FIELD OBSERVATION REPORT

Child Nutrition Building (Food Service Building, 202276 -CA8)

Report No: 26

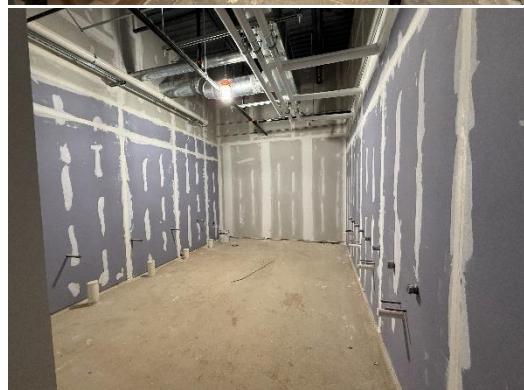
j) The control joints that were required for walls over 30' were in place.

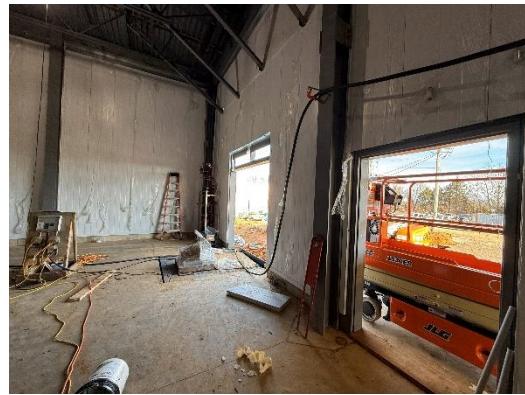
m) The walls in the toilets appeared to be ready for tile.

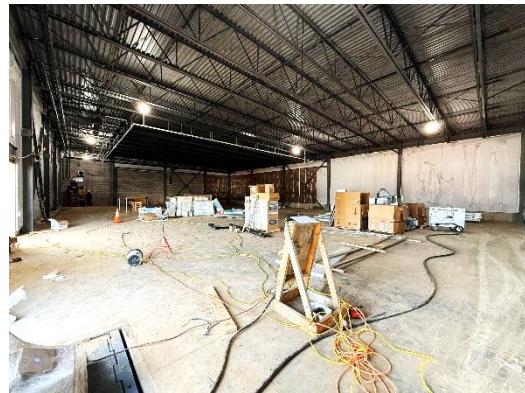
- p) Light appears to be getting into the expansion joint at the roof. This needs to be corrected.
